# Access Compliance Report

## Public Rights-of-Way

### (Curb Ramps)

Intersection ID: 5337	Main Street: UNIVERSITY_CITY_BV	Cross Street: OAK_LEIGH_DR	Location:	N
ADA ID: 4D85132713C6	Ramp Type: Perp	Initial Pass/Fail: Fail	Overall Compliance: No	Severity Score: 35
Codes/Mitigation Info/Possible Solution		Field Measurements/Component Compliance

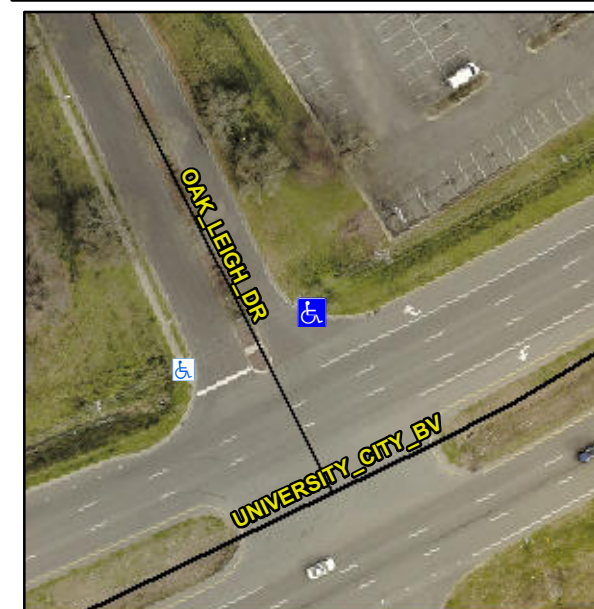
**R304.5.1, R304.2.2, R304.5.3**

Compliance	Description	Data	Compliance	Description	Data
N/A	Ramp Length (in)	39.0	No	Ramp Slope (%)	17.5
No	Ramp Width (in)	40.0	No	Ramp XSlope (%)	2.1
N/A	Flare Type LT	N/A	N/A	Flare Type RT	N/A
N/A	Flare Slope LT (%)	N/A	N/A	Flare Slope RT (%)	N/A
N/A	Flare Traversable LT?	N/A	N/A	Flare Traversable RT?	N/A
N/A	Landing Length (in)	N/A	N/A	DWS Provided?	N/A
N/A	Landing Width (in)	N/A	N/A	DWS Contrast?	N/A
N/A	Landing Slope (%)	N/A	N/A	DWS Length (in)	N/A
N/A	Landing X Slope (%)	N/A	N/A	DWS Full Width?	N/A
N/A	Landing Curb? (Y/N)	N/A	N/A	DWS Offset (in)	N/A
N/A	Shared Landing?	N/A			
N/A	Gutter Ponding?	N/A	N/A	Gutter Slope (%)	N/A
N/A	Gutter Lip Ht (in)	N/A	N/A	Gutter X Slope (%)	N/A
N/A	Painted X Walk1?	No	N/A	Painted X Walk2?	N/A
	X Walk 1 Direction	To W		X Walk 2 Direction	N/A
N/A	X Walk 1 Width (in)	N/A	N/A	X Walk 2 Width (in)	N/A
	X Walk 1 Slope (%)	3.3		X Walk 2 Slope (%)	N/A
	X Walk 1 X Slope (%)	4.5		X Walk 2 X Slope (%)	N/A

**Remove & Replace Entire Ramp.**
